Site Accessibility Evaluation

**Eastonville Road / Del Rio
Road Pedestrian Ramp
PU19-000007**

**Eastonville Rd
Peyton, CO 80831**

*Inspection Date: 11/17/2017
Inspector: David Mejia*

Finding: 1

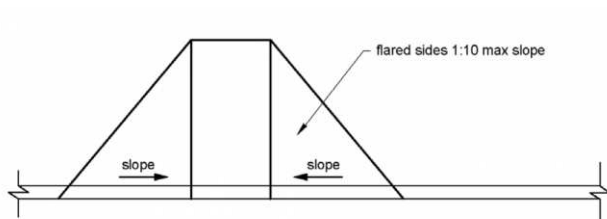
No diagonal or corner curb ramps, sidewalks exists. ADA compliance for school zone.

2010 ADAS Section: 406.3

No pedestrian ramp,
curb nor sidewalk
exist

Design and construct curb ramp for accessible path of travel. See 2010 ADAS section 4.06 for specifications and compliance. Maximum running slope of 1:12 (8.33%) and maximum cross slope of 1:48 (2.08%). if provided, curb ramp flares shall not be steeper than 1:10 (10%)
